Access Compliance Report

Public Rights-of-Way

| Intersection ID: 28389 | Main Street: ARDREY_KELL_RD | Cross Street: LANCASTER_HY | Location: SW |
| ADA ID: AB357F0E0B91 | Curb Cut Type: IslandRefuge3 | Initial Pass/Fail: Fail | Overall Compliance: No |

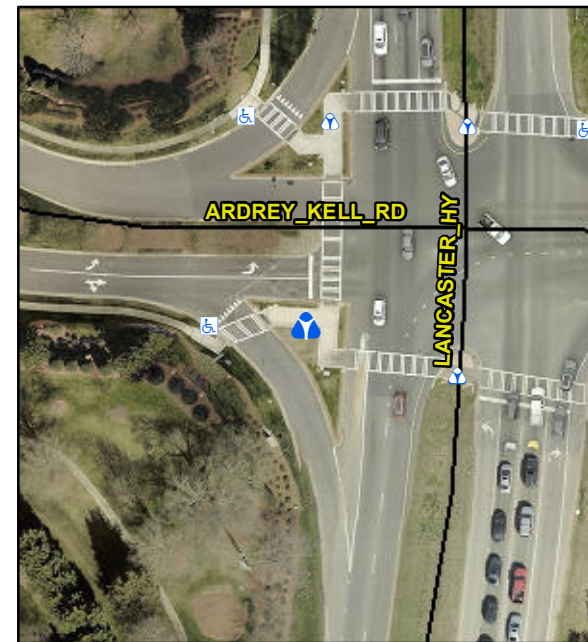
Remove & Replace Entire Refuge.
